Access Compliance Report

Public Rights-of-Way

Intersection ID: 48366	Main Street: WHEATFIELD_RD	Cross Street: SULKY_PLOUGH_RD	Location: SW
ADA ID: AC14702CC867	Ramp Type: PerpDiag	Initial Pass/Fail: Fail	Overall Compliance: No
Severity Score: 31.25			
Codes/Mitigation Info/Possible Solution		Field Measurements/Component Compliance

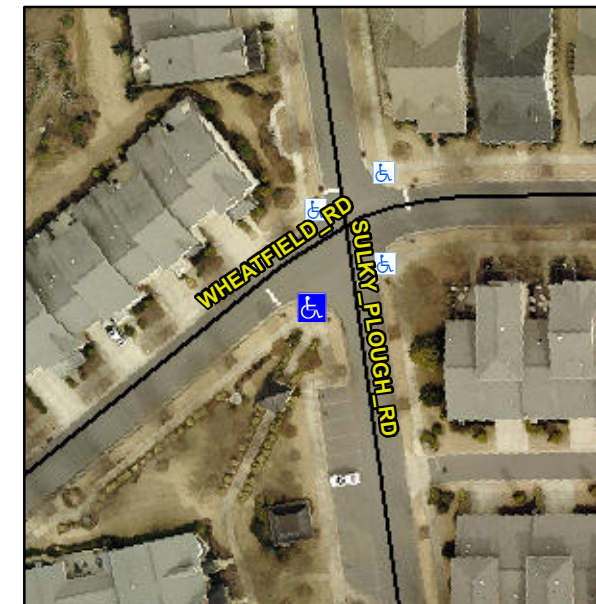
Not Found, R304.5.1, R304.2.2, R304.5.3

Compliance	Description	Data	Compliance	Description	Data
N/A	Ramp Length (in)	72.0	No	Ramp Slope (%)	10.1
No	Ramp Width (in)	32.0	No	Ramp XSlope (%)	3.7
N/A	Flare Type LT	N/A	N/A	Flare Type RT	N/A
N/A	Flare Slope LT (%)	N/A	N/A	Flare Slope RT (%)	N/A
N/A	Flare Traversable LT?	N/A	N/A	Flare Traversable RT?	N/A
N/A	Landing Length (in)	N/A	N/A	DWS Provided?	N/A
N/A	Landing Width (in)	N/A	N/A	DWS Contrast?	N/A
N/A	Landing Slope (%)	N/A	N/A	DWS Length (in)	N/A
N/A	Landing X Slope (%)	N/A	N/A	DWS Full Width?	N/A
N/A	Landing Curb? (Y/N)	N/A	N/A	DWS Offset (in)	N/A
N/A	Shared Landing?	N/A			
N/A	Gutter Ponding?	N/A	N/A	Gutter Slope (%)	N/A
N/A	Gutter Lip Ht (in)	N/A	N/A	Gutter X Slope (%)	N/A
N/A	Painted X Walk1?	No	N/A	Painted X Walk2?	No
	X Walk 1 Direction	To E		X Walk 2 Direction	To N
N/A	X Walk 1 Width (in)	N/A	N/A	X Walk 2 Width (in)	N/A
	X Walk 1 Slope (%)	1.8		X Walk 2 Slope (%)	4.9
	X Walk 1 X Slope (%)	4.2		X Walk 2 X Slope (%)	2.4

Remove & Replace Curb Ramp With Two New Directional Ramps or Equivalent.
